## Facility Conditions Assessment Questions & Answers

**MEYDENBAUER  
CENTER**

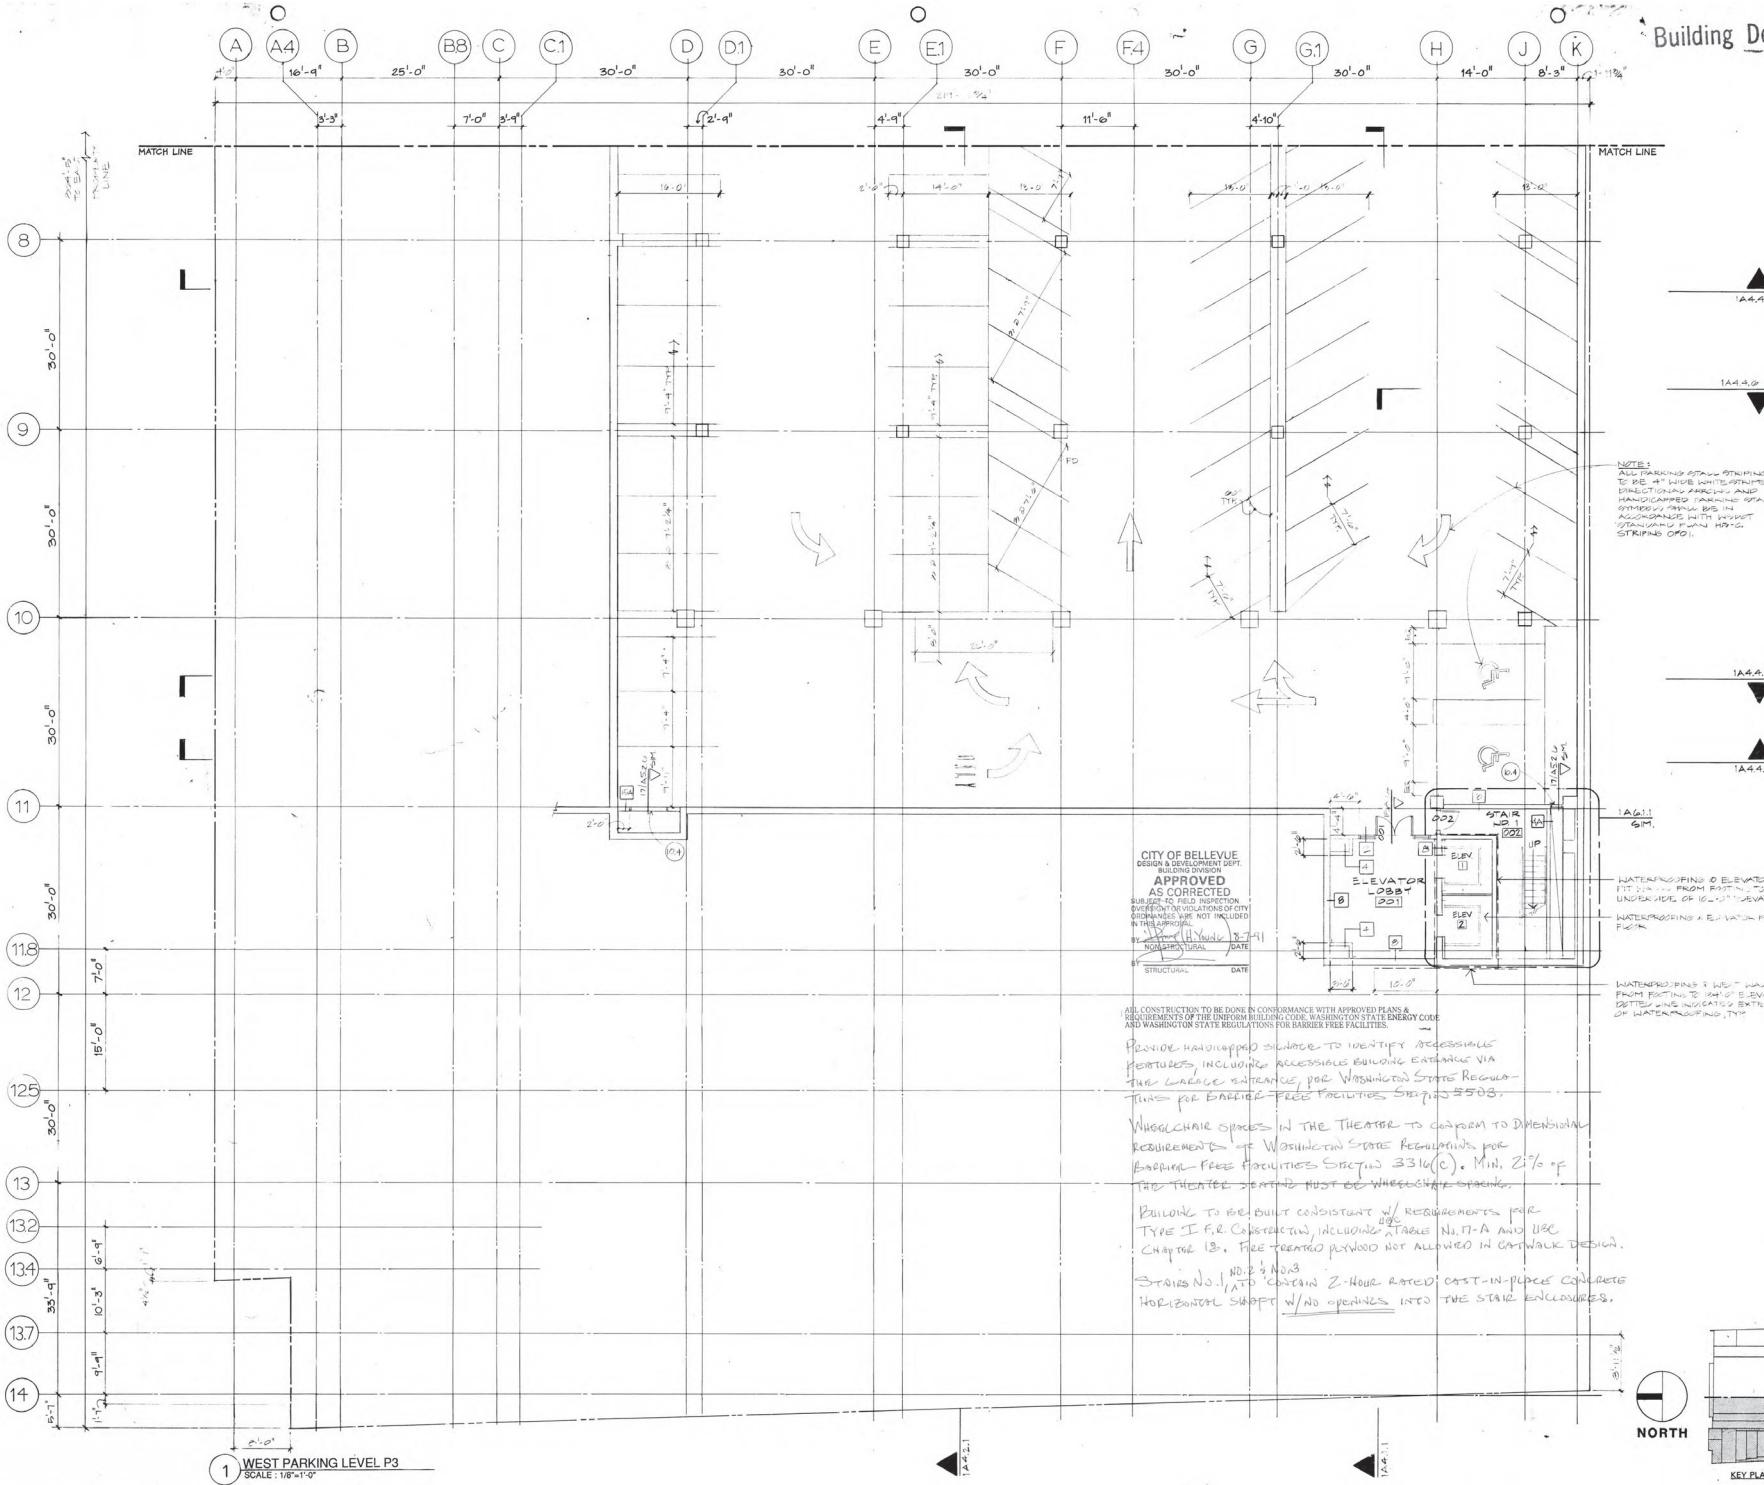
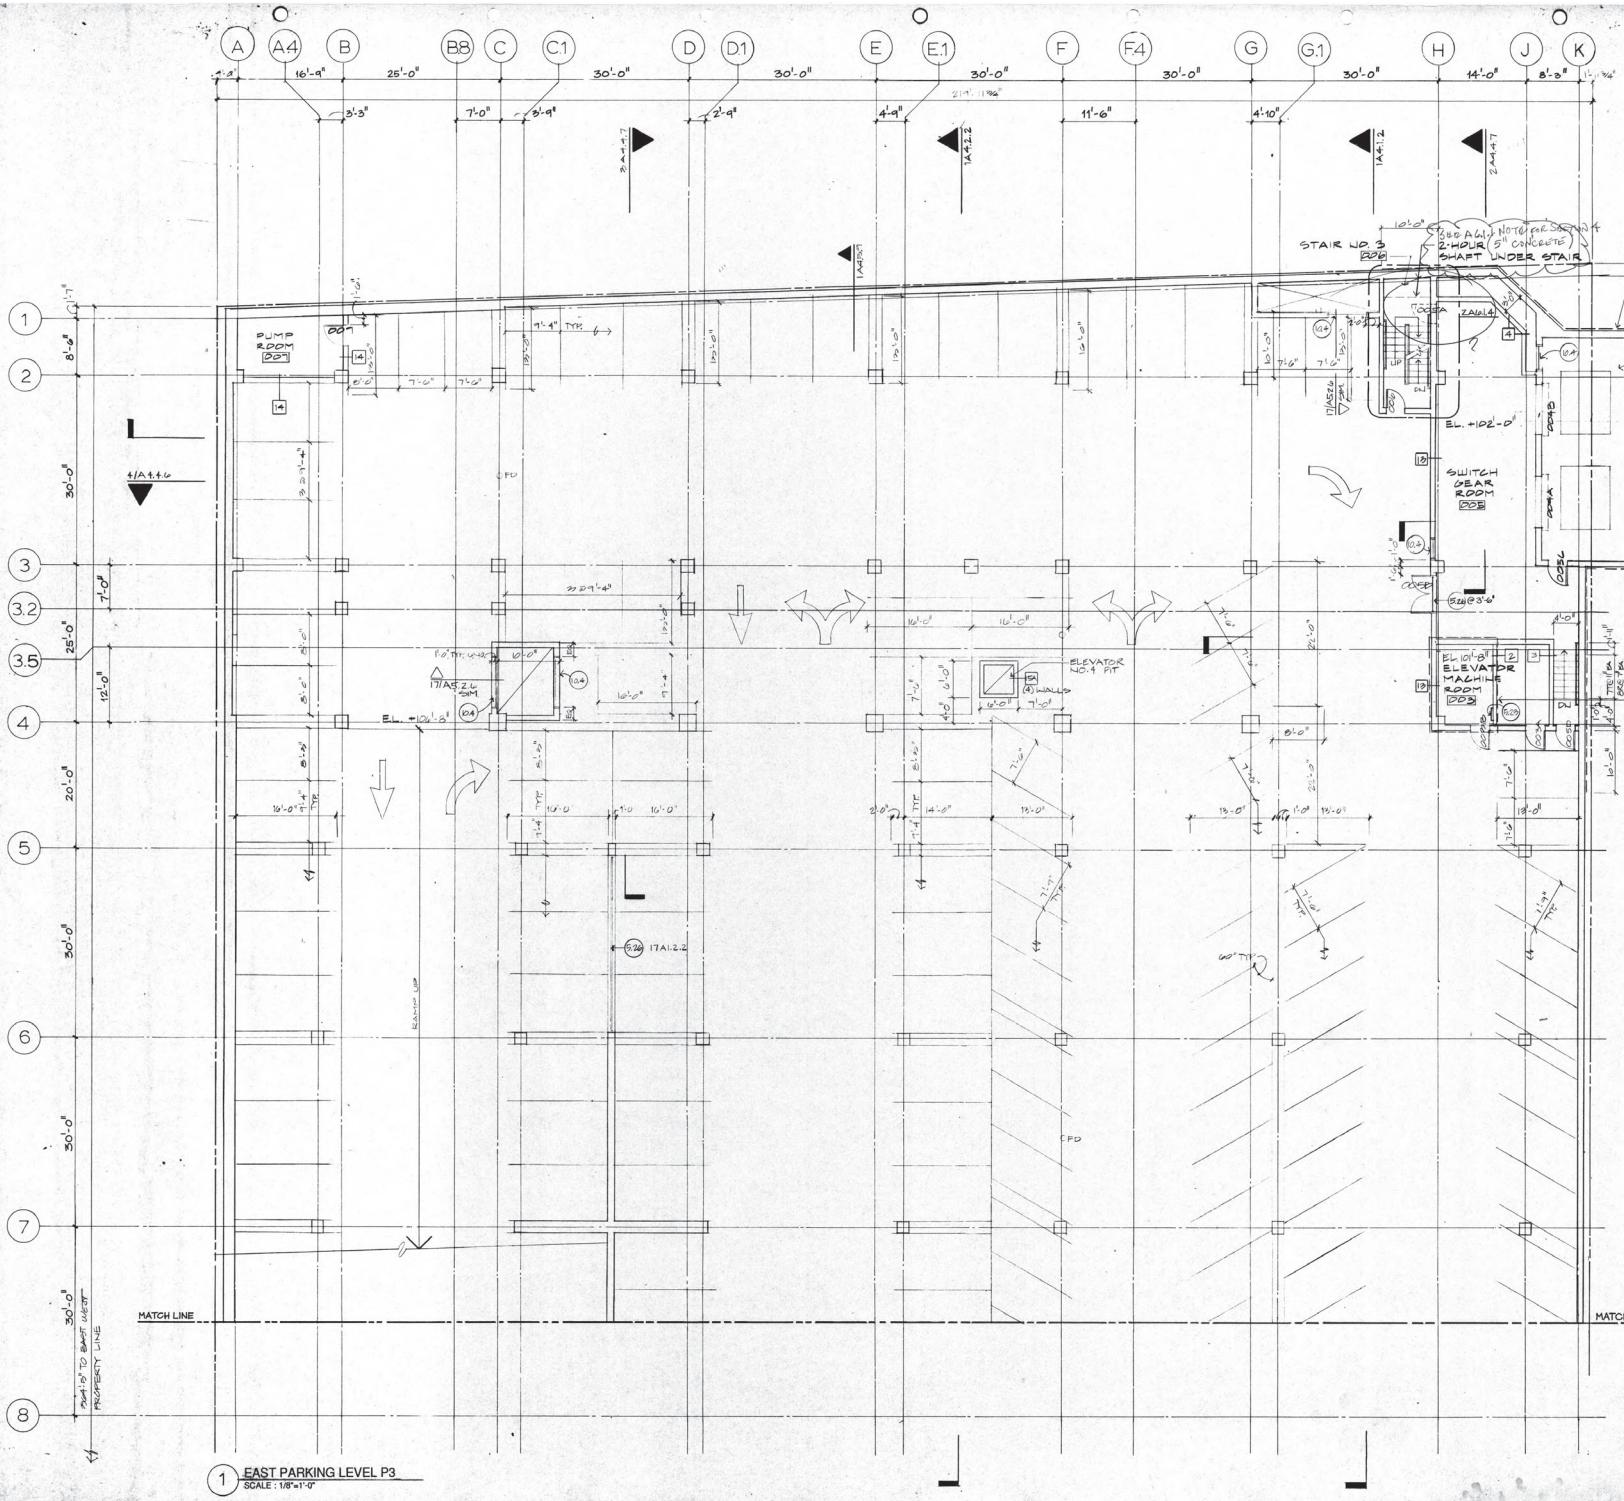
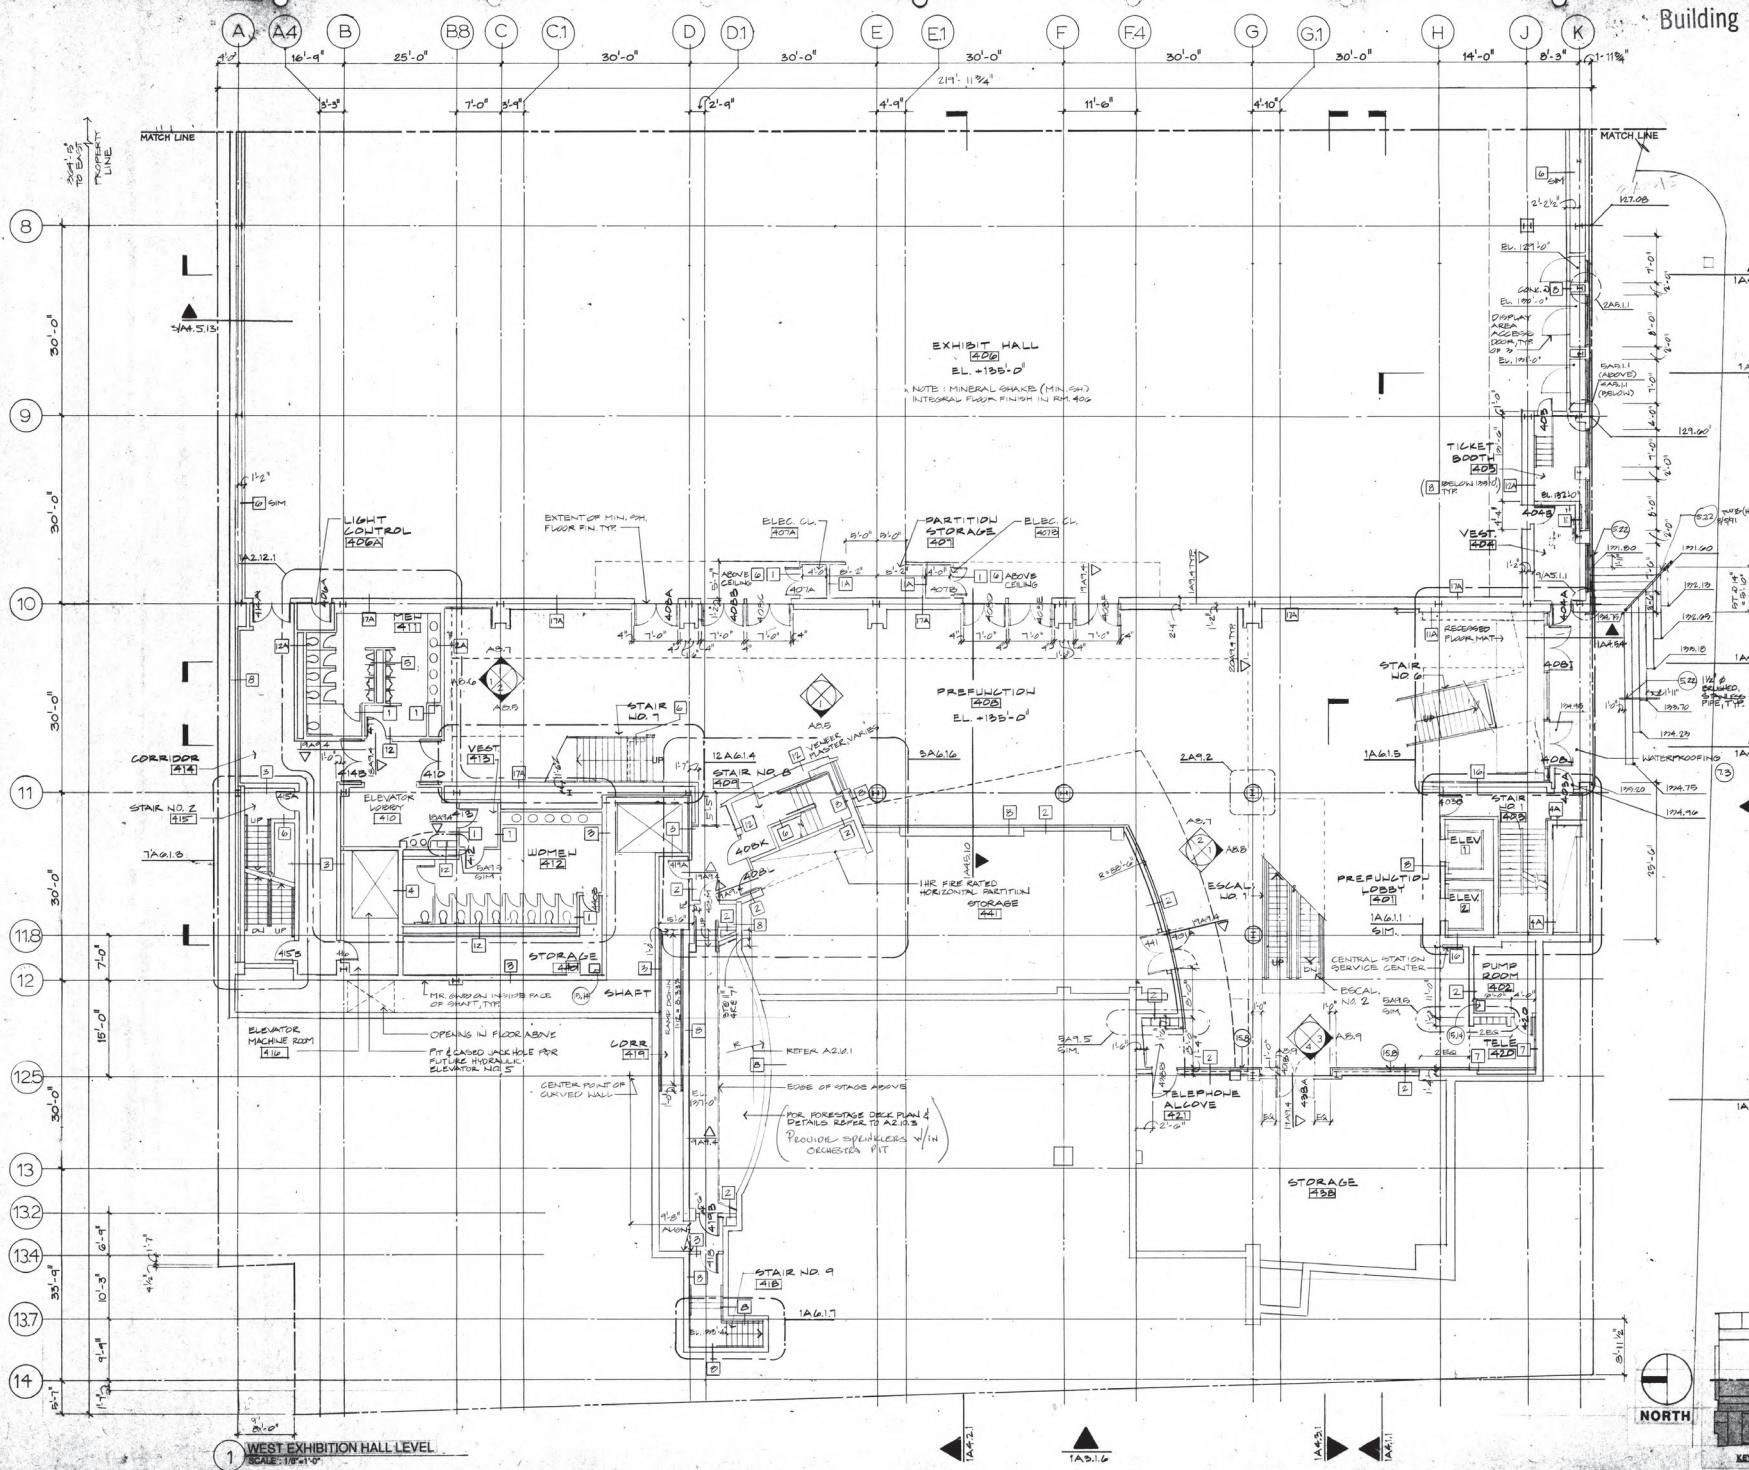
**Question:** *Would it be possible to obtain some sort of floor plans of the facility to better understand the overall layout.*

**Answer:** Included in this packet are some of the original as-builts by floor to give you a sense of the layout.
